GENERATOR TECHNICAL PERFORMANCE STANDARDS

Response to consultation paper -
November 2017

Figure 1: Proposed system standard for power frequency over voltage¹

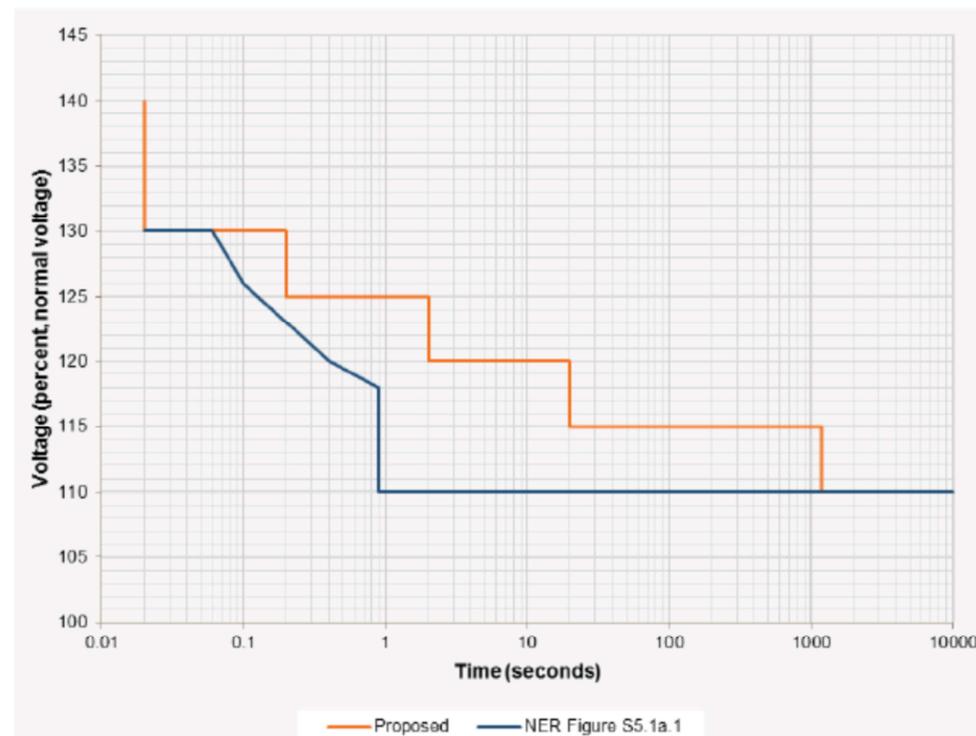
Stanwell does not consider that this has been the approach taken by AEMO during this technical standards review process. For example, Figure 1 shows the proposed system standard for power frequency over voltage. AEMO claims the current standard is inadequate because it is inconsistent with observed voltage fluctuations during recent events. It may be that these voltage fluctuations were observed during non-credible contingencies. If this is the case then the proposed standards will result in unnecessary compliance costs, which ultimately flow on to consumers.

On the other hand, if the observed voltage fluctuations were observed during credible contingencies then it is likely that NSPs have not met their voltage management obligations under the rules. This should be addressed directly with NSPs rather than through changes to generator technical standards.
